ALERT SERVICE BULLETIN

212-20-164

- MODEL AFFECTED:** 212
- SUBJECT:** FUEL CHECK VALVE P/N 209-062-607-001,
INSPECTION AND REPLACEMENT OF.
- HELICOPTERS AFFECTED:** Serial numbers 30501 through 30999, 31101 through 31311, 32101 through 32142 and 35001 through 35103 having a Circor Aerospace (Circle Seal) fuel check valve not marked "TQL".
- [Serial numbers listed above having a Circor Aerospace (Circle Seal) fuel check valve marked "TQL" are not affected by this bulletin.]
- COMPLIANCE:**
- Part I:** Within the next 25 flight hours or 30 days, whichever comes first after the release date of the revision A of this bulletin.
- Part II:** Within the next 25 flight hours or 30 days, whichever comes first after accomplishment of Part I and every 25 flight hours or 30 days thereafter until Part III is accomplished.
- Part III:** No later than 600 flight hours or 12 months, whichever comes first after accomplishment of Part I.

Figure 3. Fuel Check Valve Outside Diameter Measurement

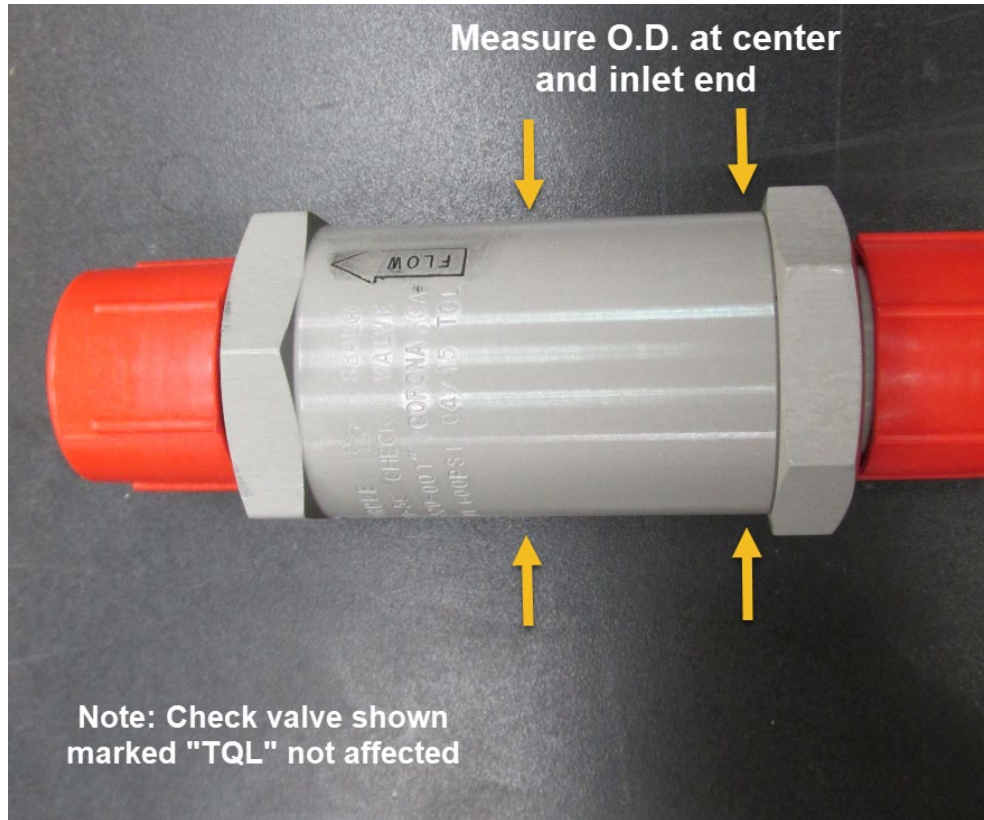
- d. If the dimension measured at the inlet end is greater than 0.003 inch (0.0762 mm) when compared to the measurement at the center, the valve will require replacement. Part III can be accomplished immediately, or Part II can be accomplished until the defective valve can be replaced in accordance with Part III.
- e. If the defective check valve is not replaced immediately, make an entry in the helicopter logbook and historical service records indicating the findings and that Part II must be accomplished every 25 flight hours or 30 days whichever comes first until Part III is accomplished.

Figure 4. Cracked Fuel Check Valve

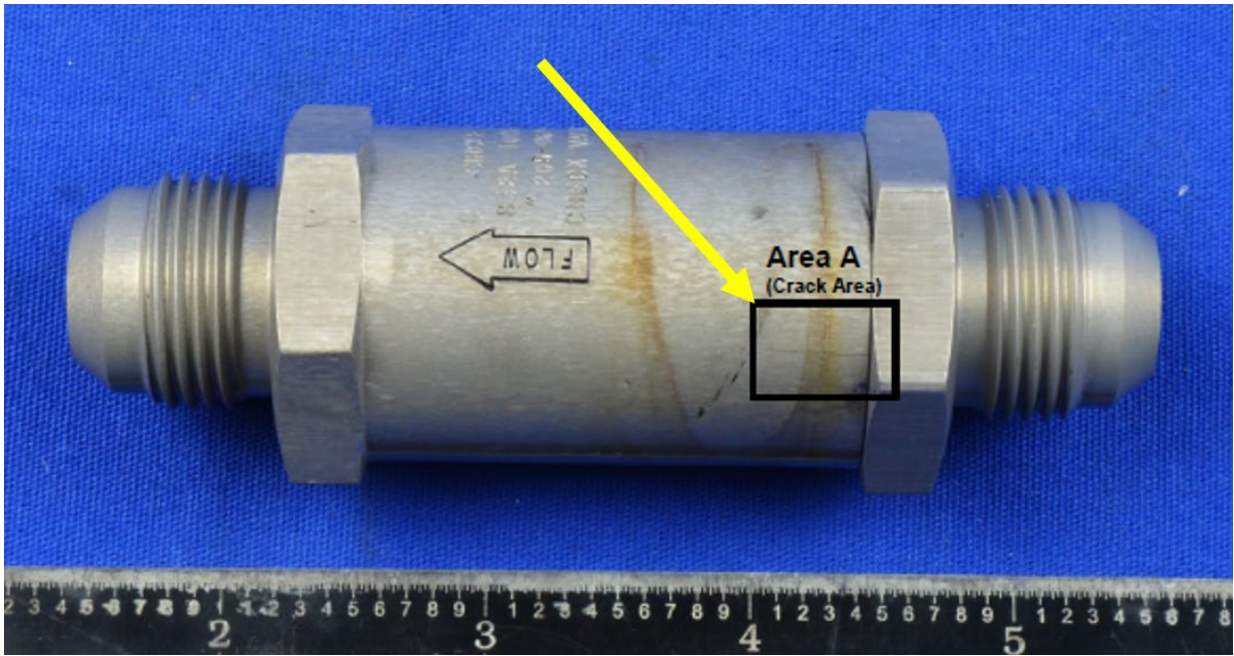
1. Prepare the helicopter for maintenance and gain access to the fuel check valves (Figure 1).
2. Using a strong light source, visually inspect the fuel check valves for general condition and fuel leaks. Inspect for cracks at the inlet end where the threaded fitting is installed (Figure 3).
3. If a crack is found, replace the check valve prior to next flight. Figure 4 shows an example of a cracked check valve.
4. If no cracks or any other defects that would cause the valve to be unserviceable are found, make an entry in the helicopter logbook and historical service records indicating the findings and that Part II will require accomplishment until Part III is accomplished.
